ITEM 5. DEVELOPMENT APPLICATION: 65 CRAIGEND STREET
DARLINGHURST

FILE NO: D/2015/565

Proposal Summary: Stage 1 DA for redevelopment of the site for use as a vehicular sales showroom and hire premises, service and repair centre, and office. The proposal includes demolition of all existing buildings, concept approval for 5-storey (18m) building envelopes and above ground car parking.

Figure 23: Building envelopes proposed under original scheme

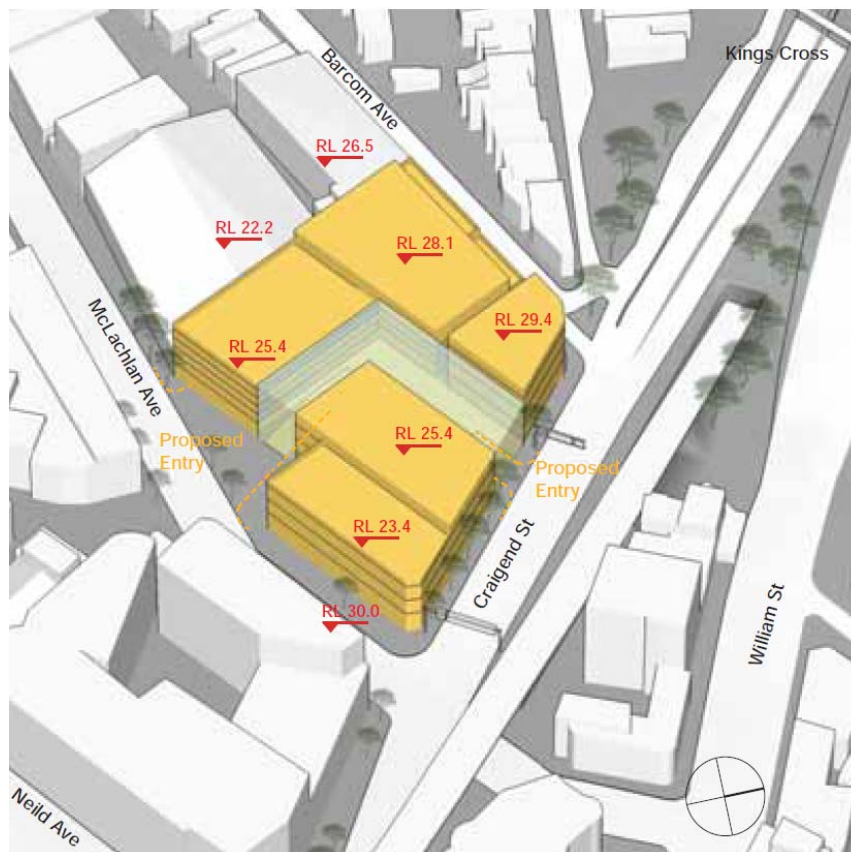
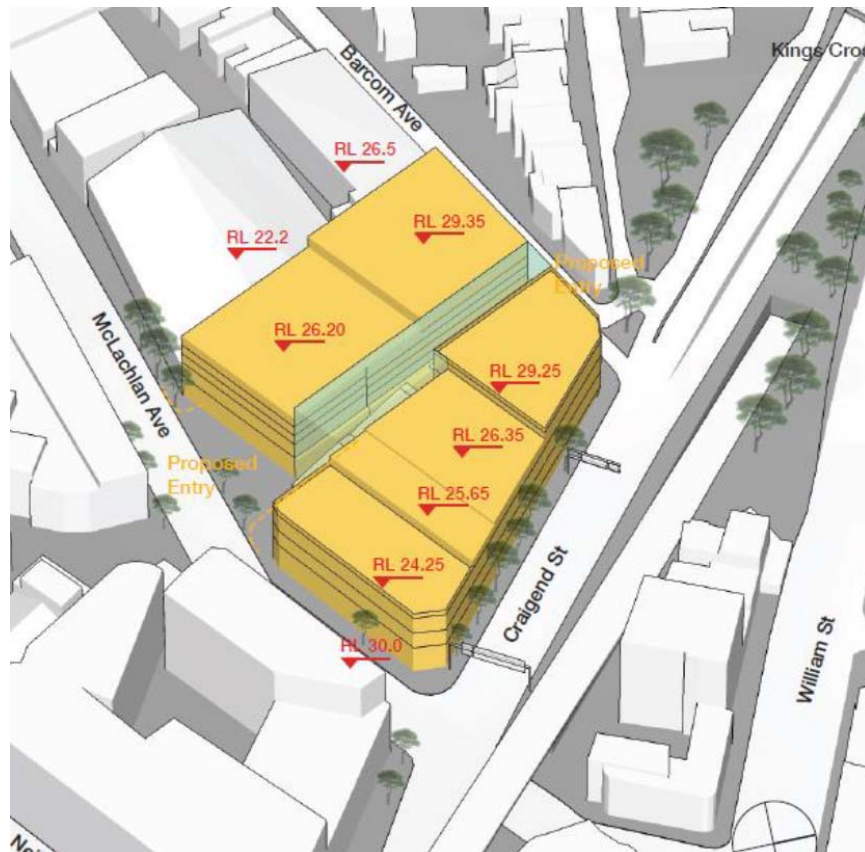
17. The City's Public Domain Unit also raised concern with the original proposal as it directed overland flow of stormwater through the site. In response the finished levels on Barcom Avenue have been amended to direct flows down Barcom Avenue to Craigend Street. The applicant has also elected to decommission and relocate the existing substation in order to avoid any interaction with potential overland flow paths. The final location of the substation will be determined in the future Stage 2 DA for the detailed design.

18. The above mentioned modifications necessitate amendments to the building envelopes. The original layout is shown in Figure 23 and the revised layout in Figure 24.

Figure 24: Building envelopes proposed under the revised scheme

Figure 28: Proposed building envelope, viewed from above

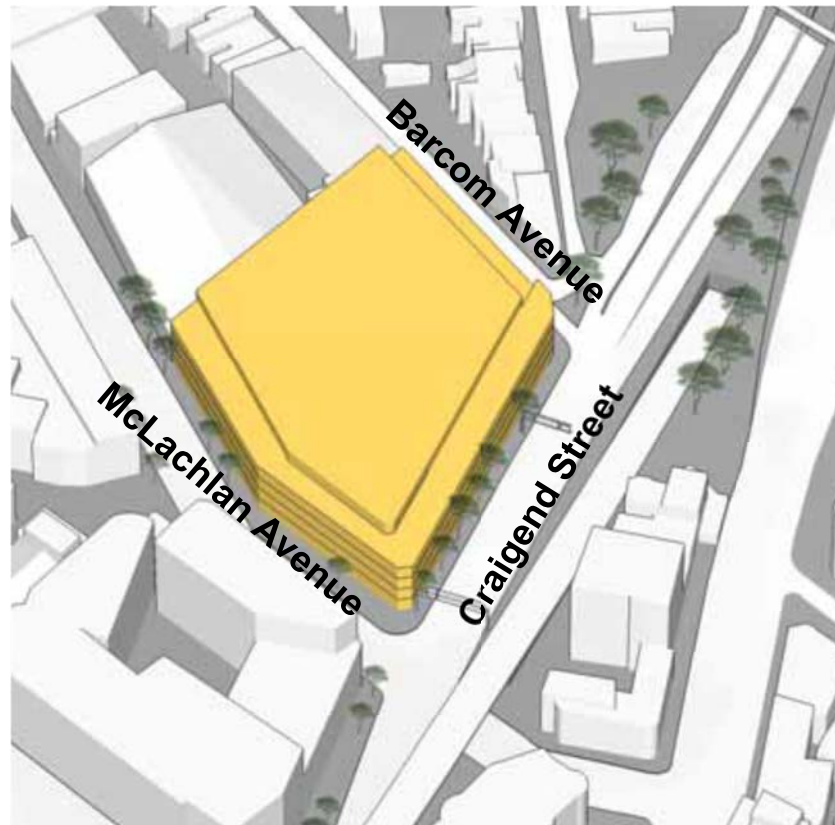
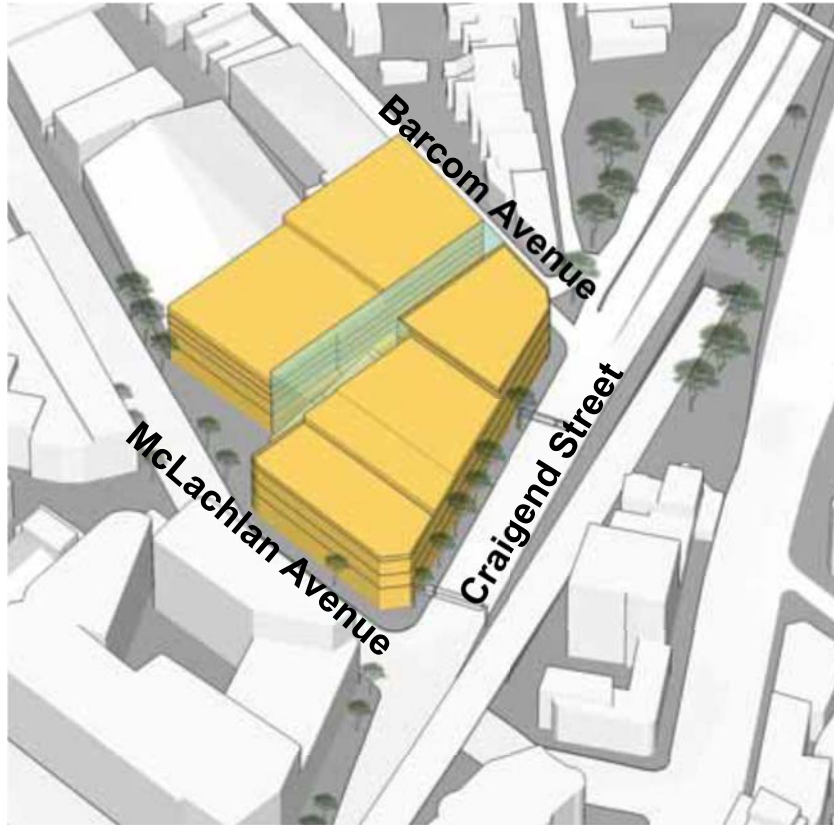
43. The proposed non-compliance on the corner of McLachlan Avenue and Craigend Street is considered to be acceptable given this is a landmark corner. The DCP controls for car showrooms encourage high floor to ceiling heights for car show room on ground and first floor level, however strict compliance with the control would require a 3m setback above a height of 15.1m. From an urban design perspective, a superior outcome may be achieved for a development of this nature if the setback is not strictly enforced. It is noted that a more substantial setback is provided elsewhere along the McLachlan Street frontage.

Figure 31: Flood levels during the 1 in 100 year flooding event.

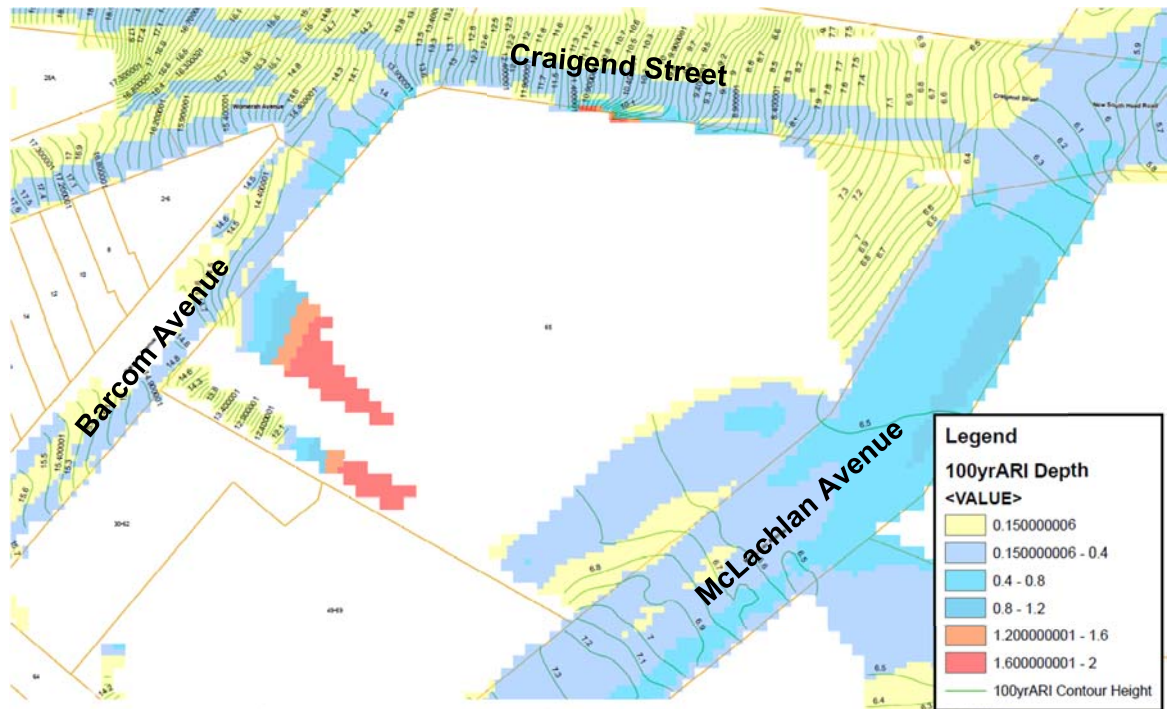
62. Concerns were raised with the original proposal, as it included an overland flow path through the site from the ramp on Barcom Avenue through to McLachlan Avenue. The application was amended to change the floor levels along Barcom Avenue, in order to direct flows along Barcom Avenue and down Craigend Street. The revised proposal is considered acceptable in terms of overland flow.

63. The proposed building envelopes align with the adjoining property fronting McLachlan Avenue at the boundary, and incorporate a partial setback within the central portion of the frontage. This results in building envelopes within the flood affected area. Given the nature of the proposal, this is acceptable in principle subject to additional testing and modelling informing the architectural response to these constraints and appropriate measures being incorporated into the Stage 2 design.

64. In light of the above, additional information is required to support the Stage 2 DA, including a Flood Assessment and a Stormwater Drainage and Disposal Concept Plan. It is also a requirement that the Stage 2 Design complies with Sydney Water's requirements for on-site detention. A condition of consent is recommended accordingly.
